FREMONT COUNTY

Unknown Pavement-Grade and Replace
STP-002-1(152)--2C-36

PLANS OF PROPOSED IMPROVEMENT ON THE
PRIMARY ROAD SYSTEM
FREMONT COUNTY
 Unknown Pavement-Grade and Replace
 01 mi E of 342nd Ave to
 East Nishnabotna River

PRELIMINARY PLANS

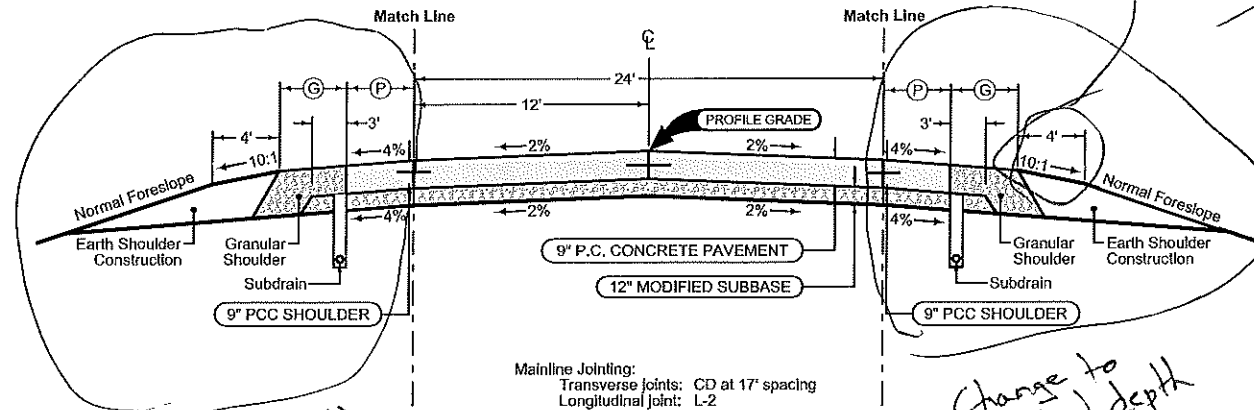
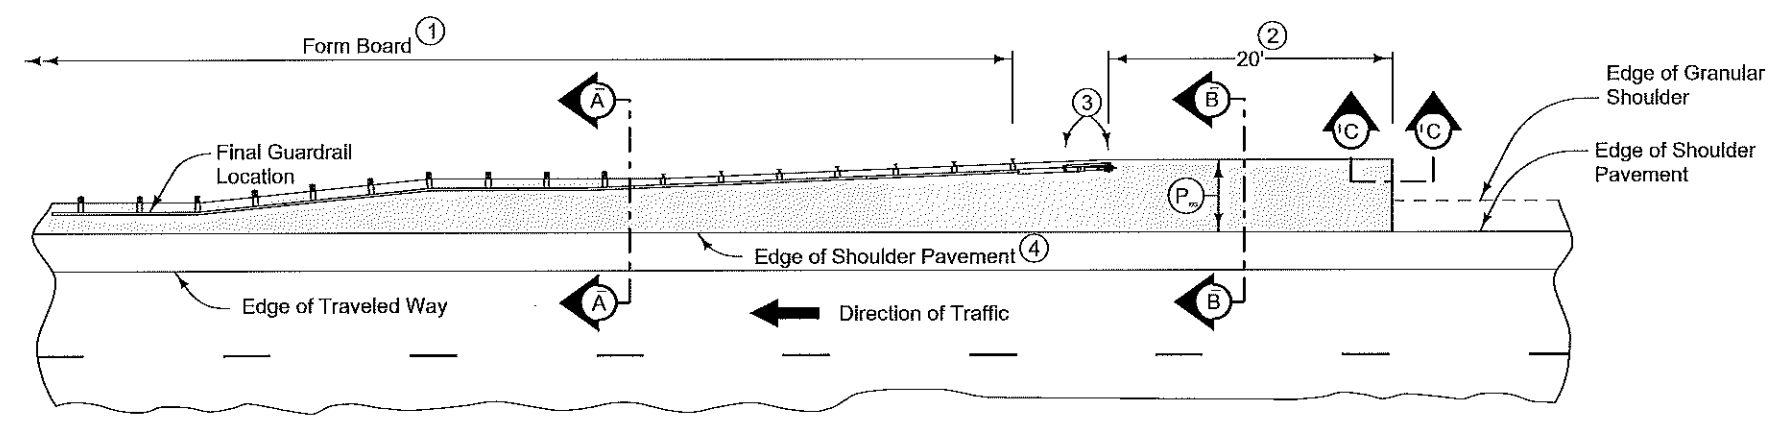
Change to partial depth

Change to partial depth

run to Christ Brake or Daving.

*3.5" paved shoulder
 alternates
 7" for ag traffic
 HMA*

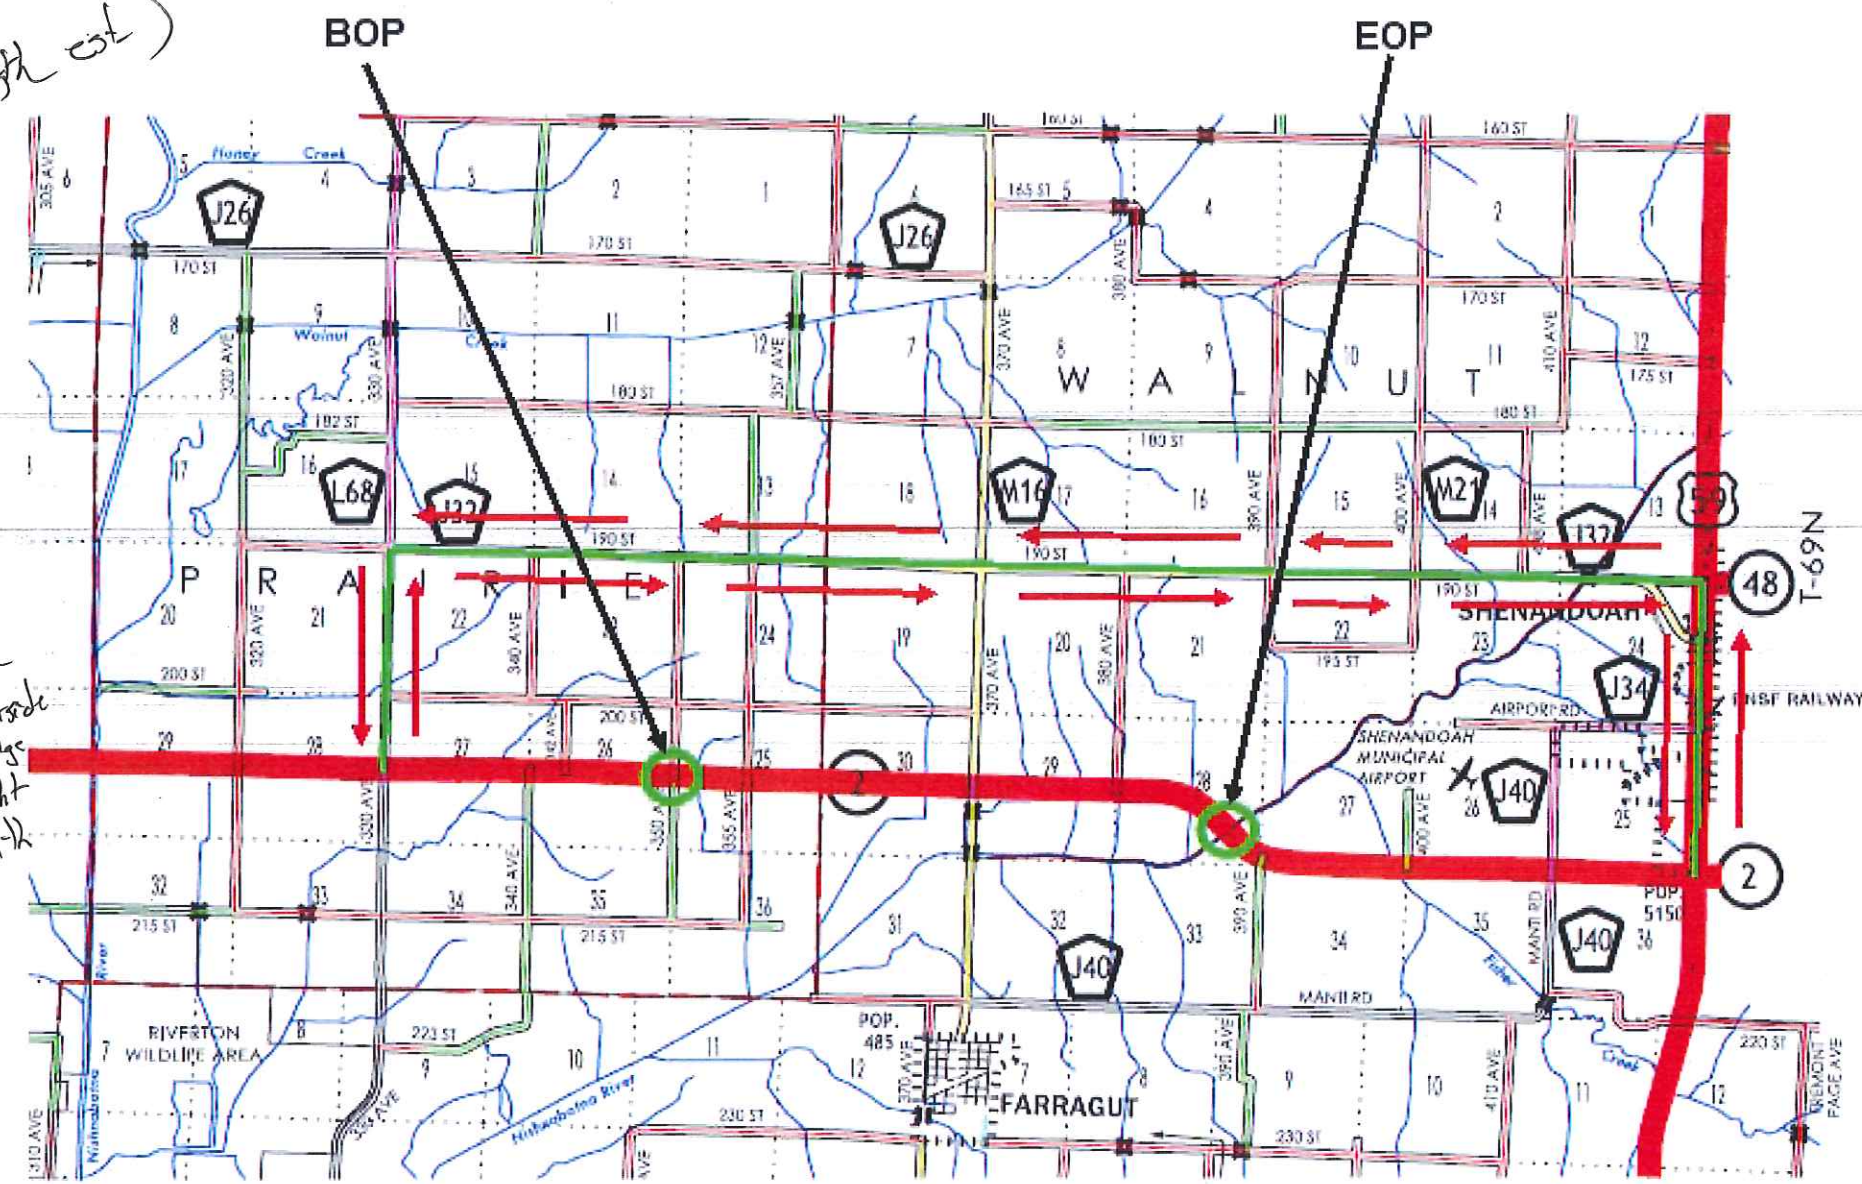
Add paint for detour.
 (add general length est)
 edge lines
 Patching N/S L68

Note Road closed ahead
 at M16/detour
 intersection

NB
 (26th address)
 30' x 12' 110' x 6' outside
 edge right
 8" pavement
 20' x 6'
 40' x 12'
 SB 60' x 12'
 40' x 12'
 40' x 24'
